ADDENDUM NO. 2

NORTHWEST DEVELOPMENT AREA WATER AND SANITARY SEWER IMPROVEMENTS DAYTON INTERNATIONAL AIRPORT (10% MBE Participation)

ITEM NO. 1 – Bid Set Drawing Sheets

C2-8

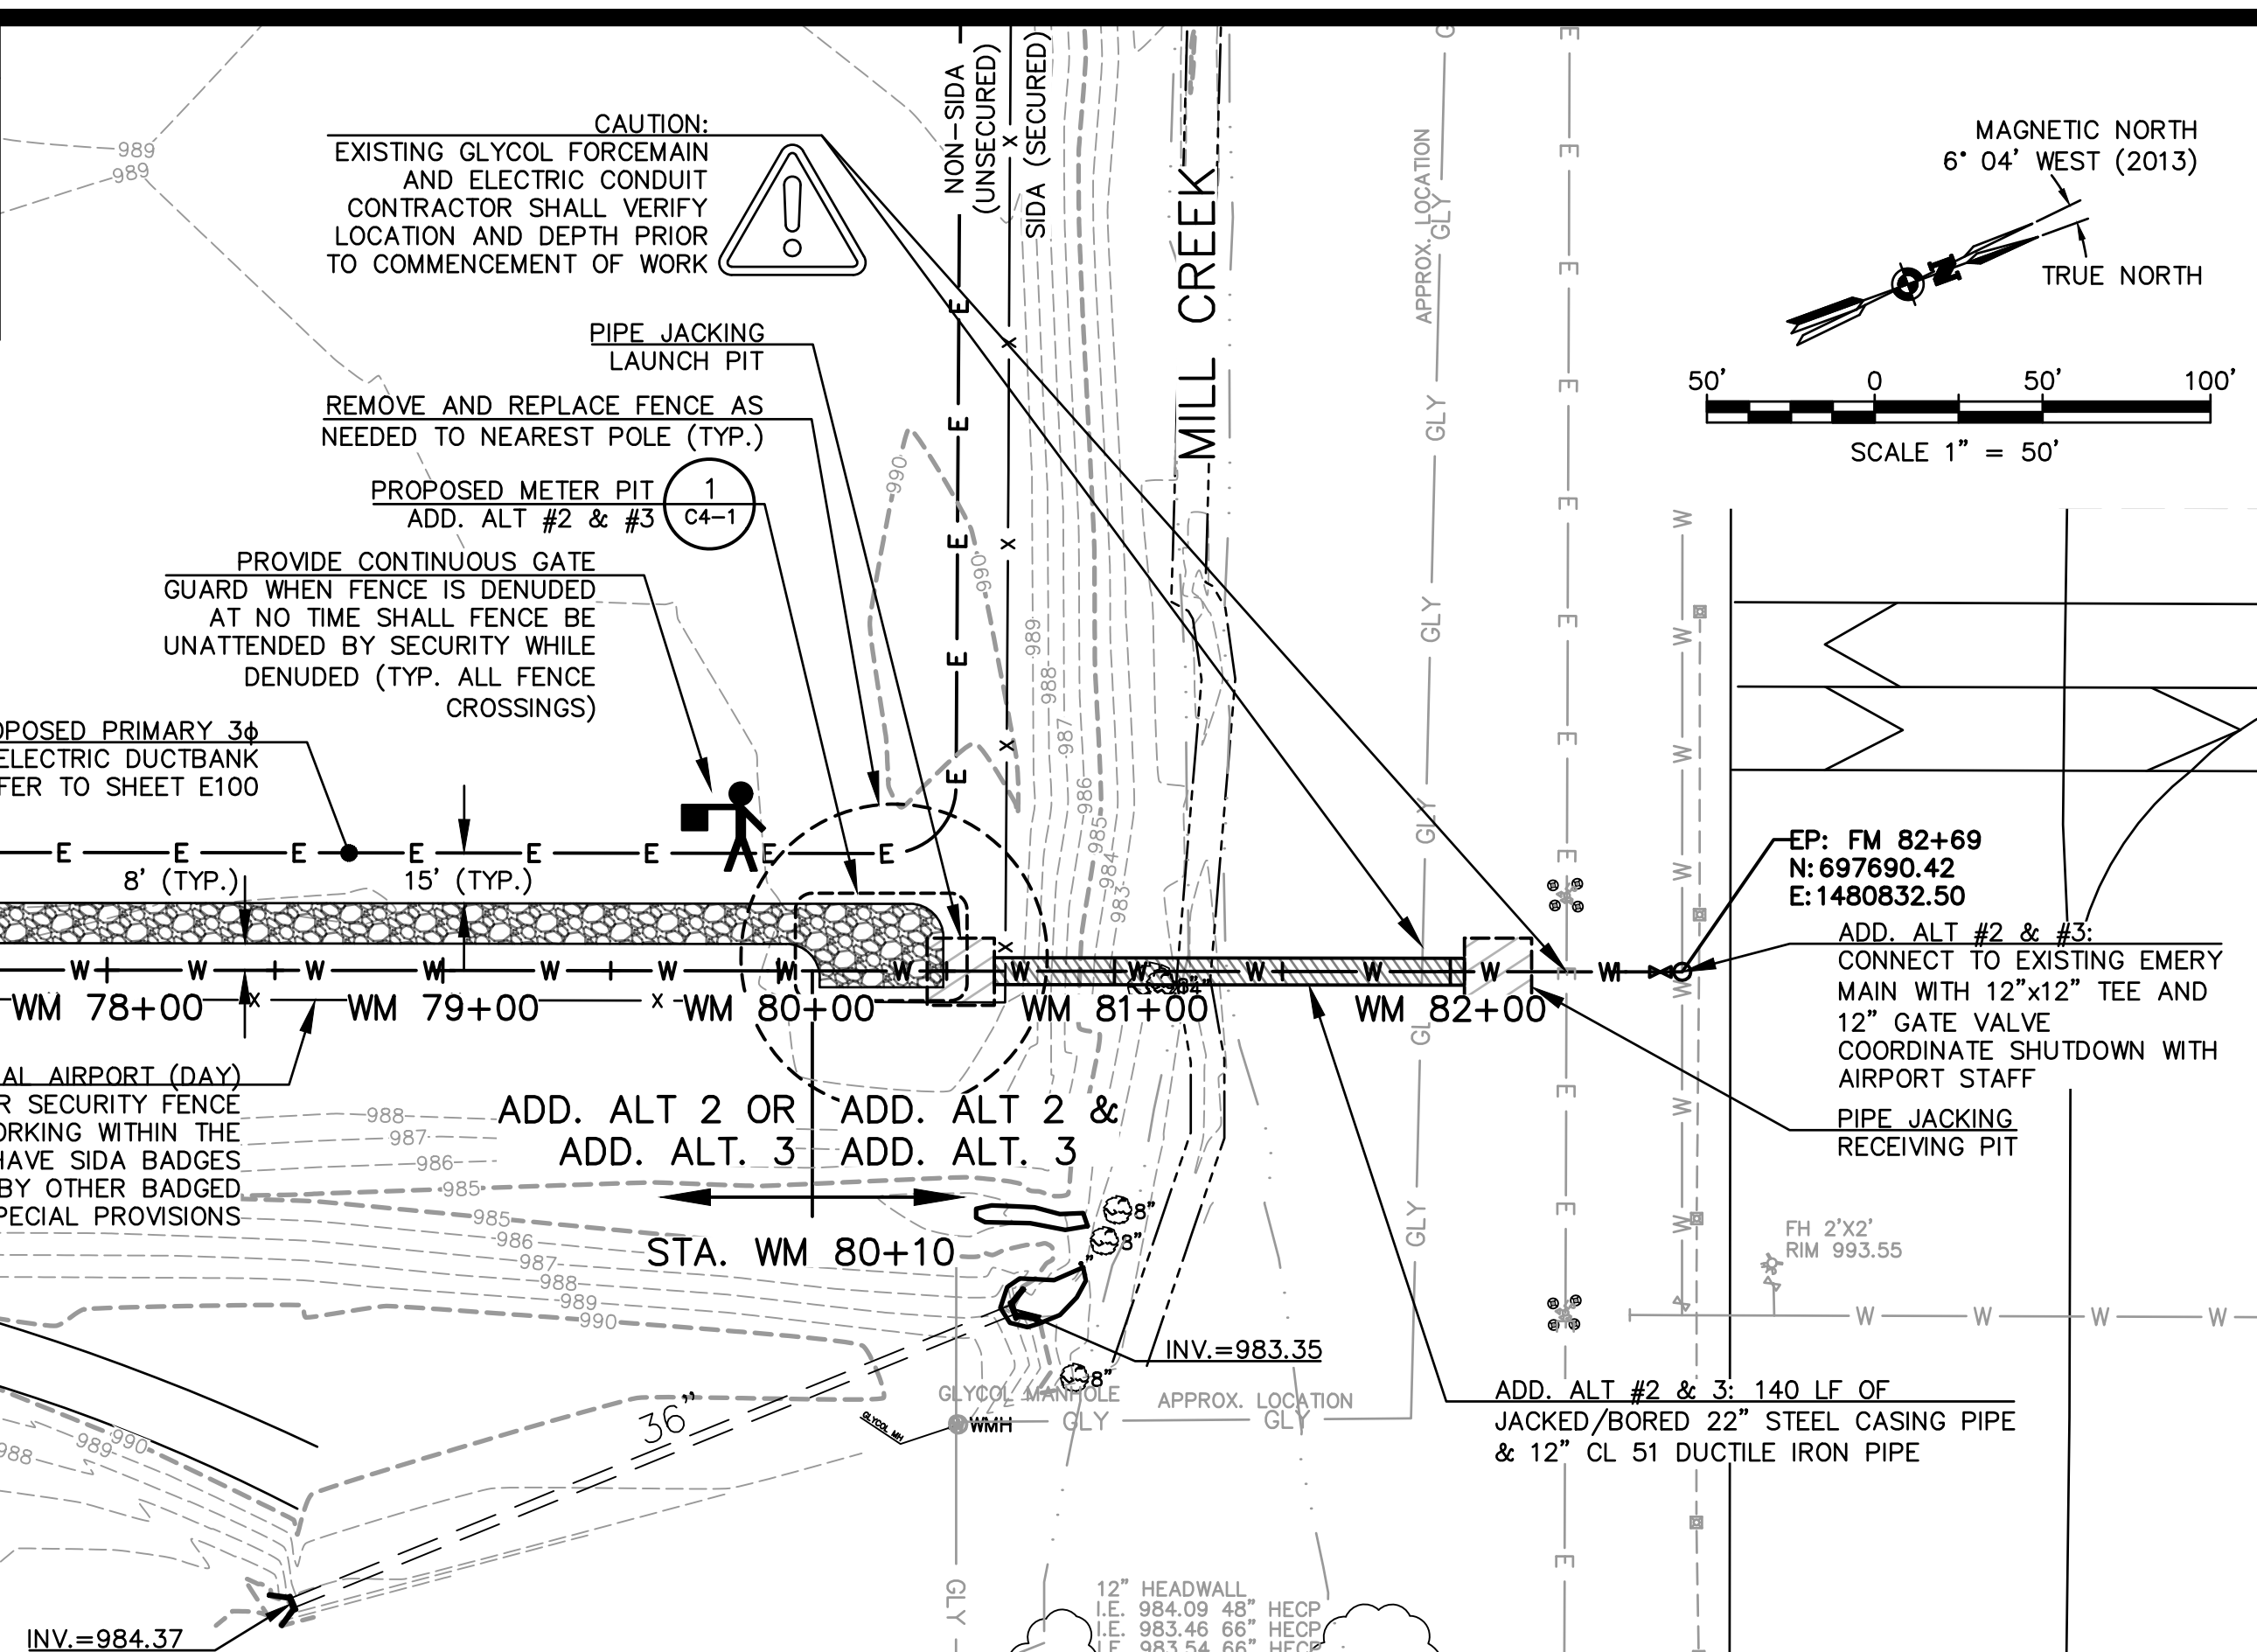
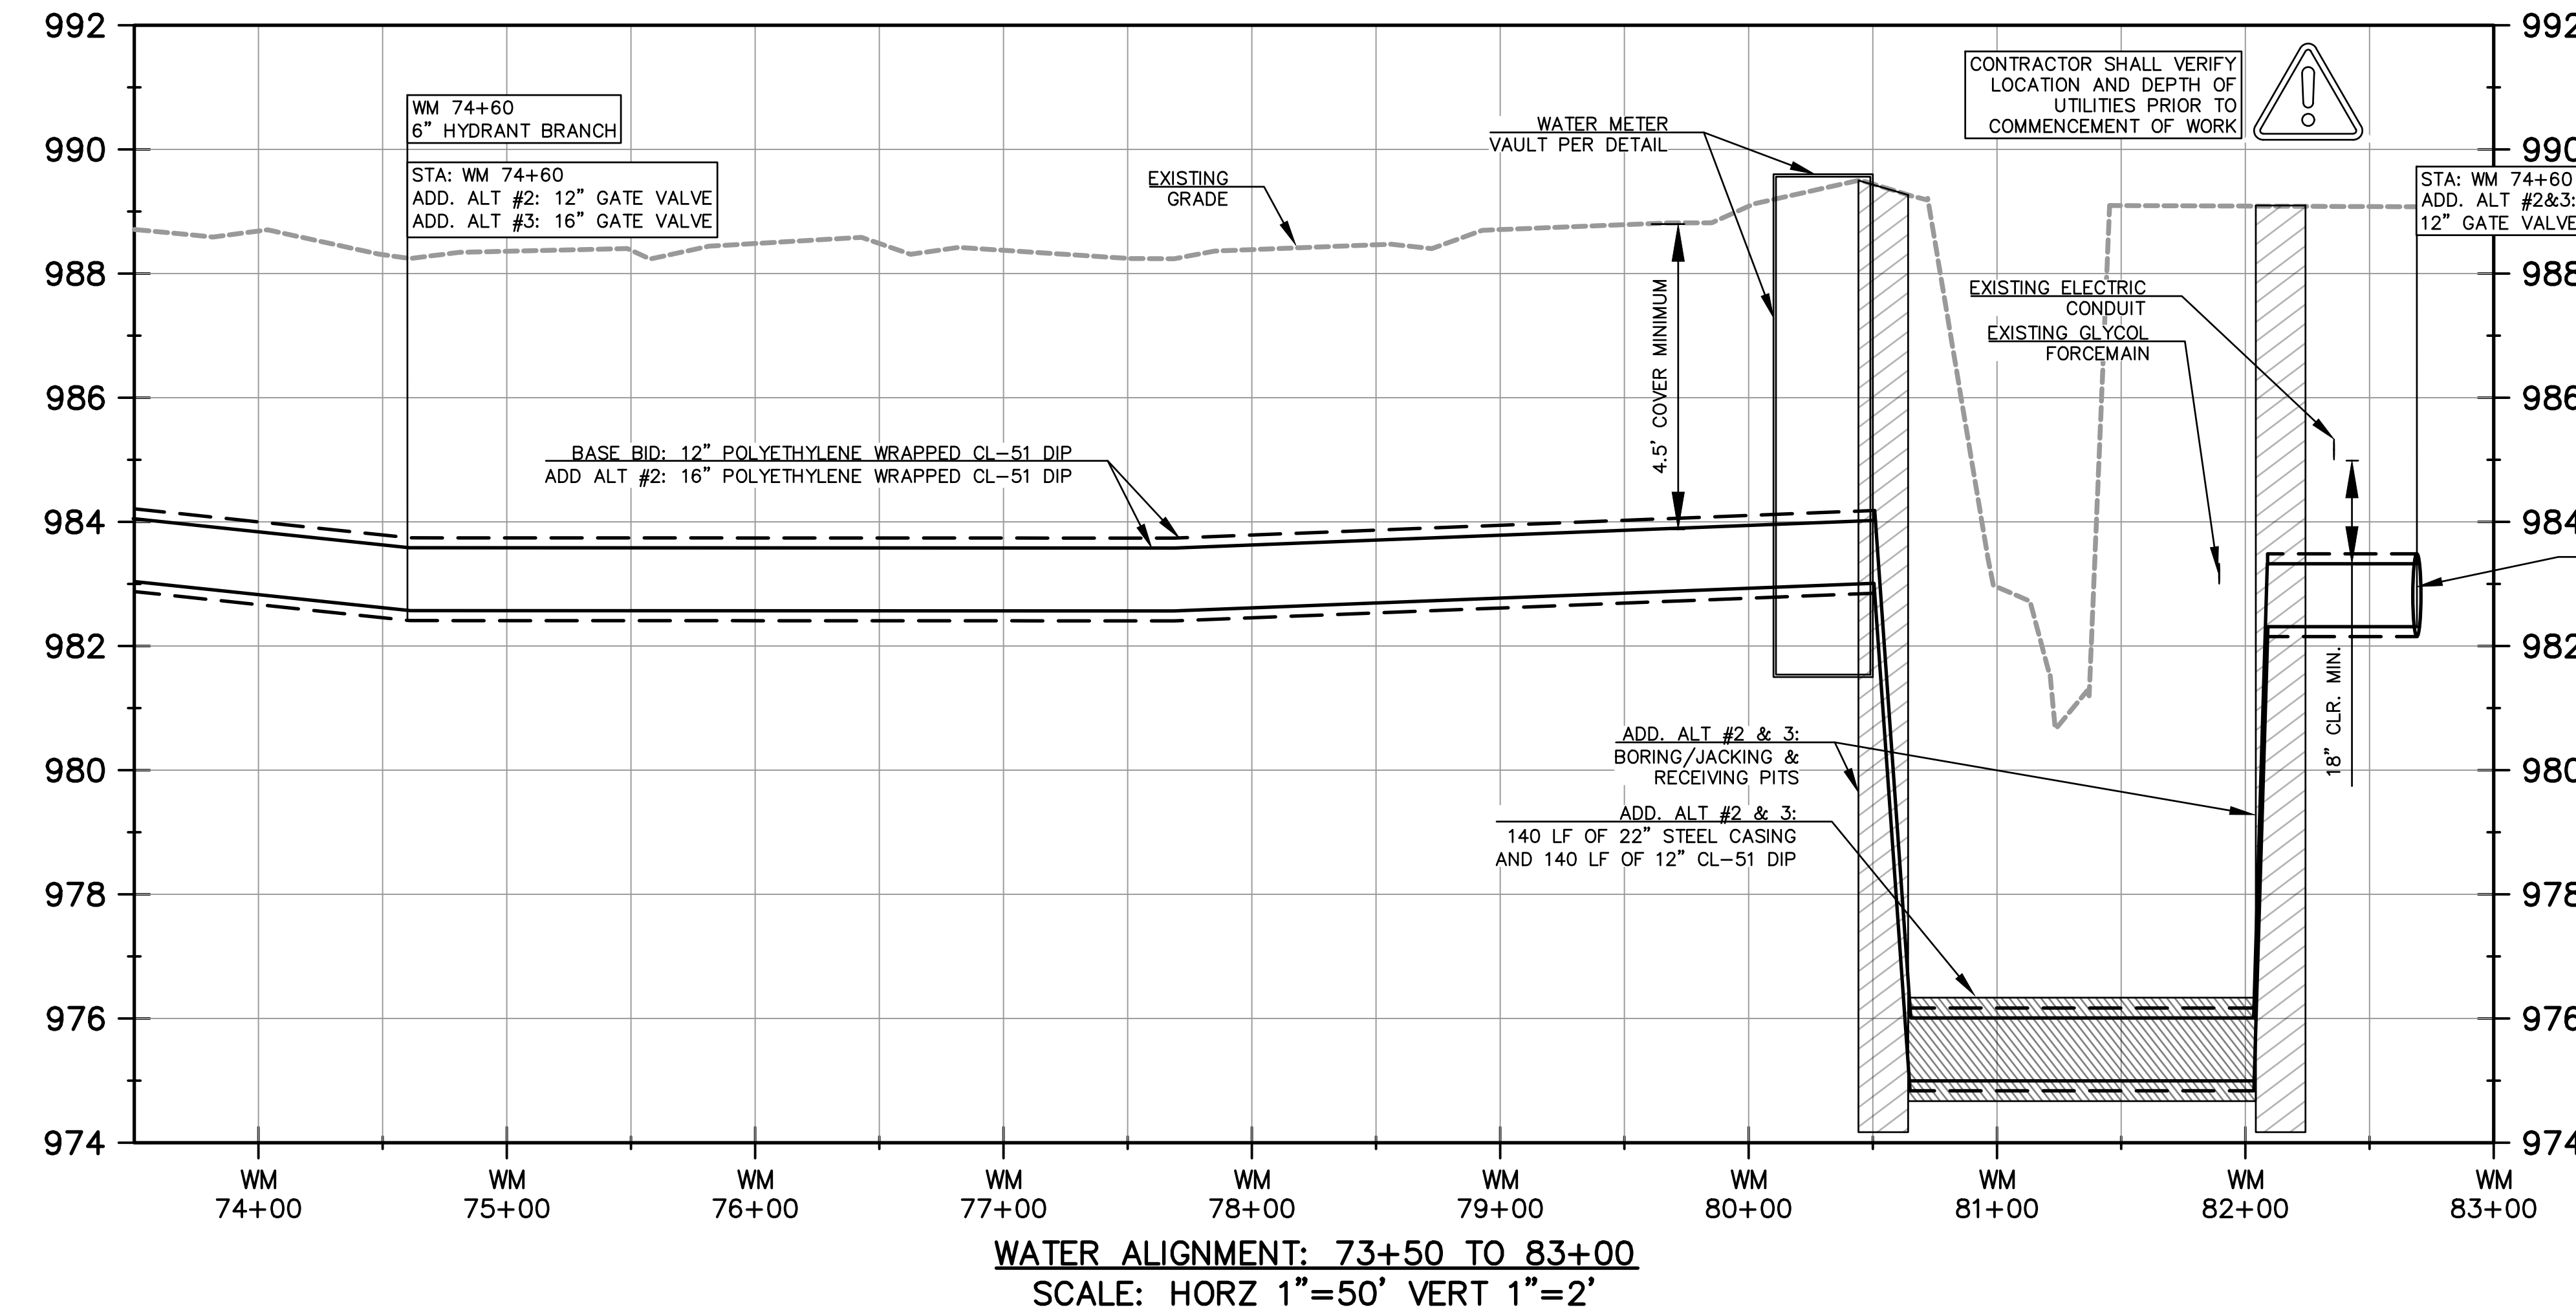
Clarification and Revise: Water main installation from Sta 55+50 to 82+69 is under Additive Alternate No. 4 on the Bid Proposal Form. Change all references from Add. Alt #2 to Add Alt. #4.

Clarification and Revise: Water main installation to upsize from 12" to 16" is from Sta 55+50 to 80+10, Meter Pit Start. The piping under Mill Creek to remain 12" ductile iron pipe. Change all references from Add. Alt #3 to Add Alt. #7 and #8.

Change: "8" Badger Recordall Fire Service Meter" to "8" Badger Recordall Combo Meter"

Change: At Sta 82+69, "Connect to Existing 12" Watermain with 12 x 12 Tee and Valve" to "12" Water Main Tapping Valve and Sleeve by City of Dayton, Contractor to Dig & Excavate"

Add: 2 - 8" Underground Gate Valves to be connected to the 8 x 8 tees leading to second meter pit; 1 – 12" Valve at 12 x 8 Reducer
